SunShare's First IE Dispute for Linden
Attachment C: 8 of 18

February 19, 2016 Linden Study Report

Xcel Energy's Response to Intake Form Dated 8/14/2018

Figure 8 – Pst Statistical Summary

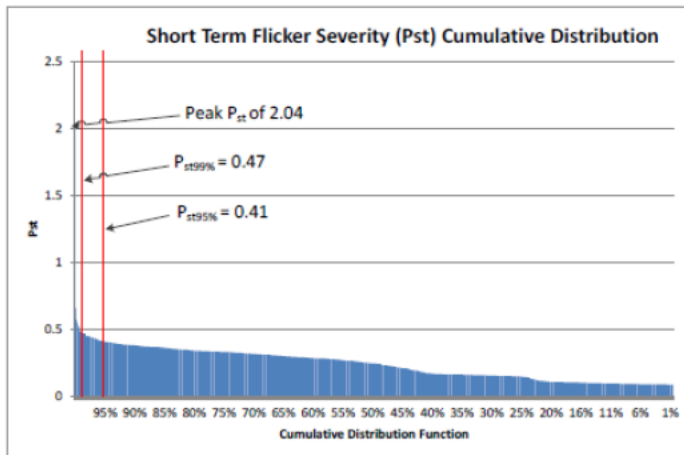
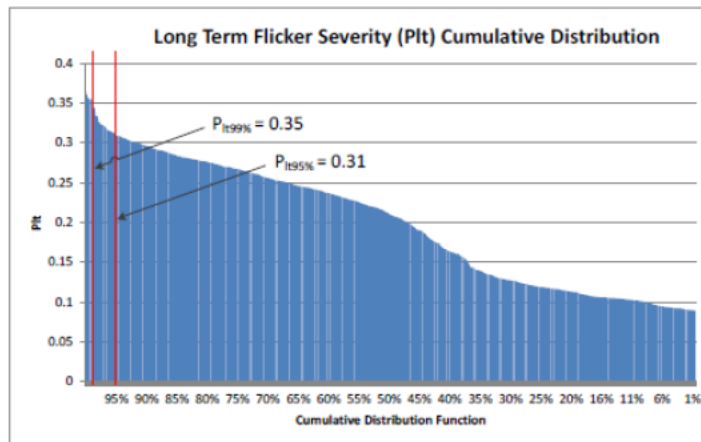
| Issue Number 2 | |
|--|---|
| Succinct description of engineering issue. | <p>Tariff Section 10 states that the maximum value of allowable Flicker is 4%, which was written in the mid-2000's prior to the mass entrance of AFI's into the renewable energy market. In a previous dispute at the Glazier project, the IE determined that it is reasonable that Xcel use a value of 2.0% for Flicker in both "aggregate" and "individual" PV systems for interconnection modeling.</p> <p>However, following this IE ruling on the Glazier/Foxtrot/Blue Heron/Cold Spring site, the PUC required that Xcel provide an assessment of the impacts from voltage fluctuation and flicker, if any, on its system within three months of the operation (and annually thereafter) of the Glazier project, which was designed and interconnected using a 2.0% assumption in models. This was done to provide more insight on the practical impacts to the PUC for future consideration. In the compliance report, both the short-term and long-term flicker severity calculated from measured data was approximately half of the planning levels from the relevant Standard. Therefore, we believe that the 2% assumption is too conservative given the actual performance data tracked at the direction of the PUC, since the measured data at a project designed with the 2% assumption experienced flicker much lower than allowable limits.</p> <p>Per the Glazier Compliance Report: <i>"Figure 8 depicts the short term flicker severity cumulative distribution for Pst which shows Pst-99% = 0.47 and Pst-95% = 0.41. These values are below the Pst planning level of 0.9, which indicates no violation in short term flicker severity is observed."</i> <i>"Figure 9 depicts the long term flicker severity cumulative distribution for Pst which shows Pst-99% = 0.35 and Pst-95% = 0.31. These values are below the Pst planning level of 0.7, which indicates no violation was observed."</i></p> |
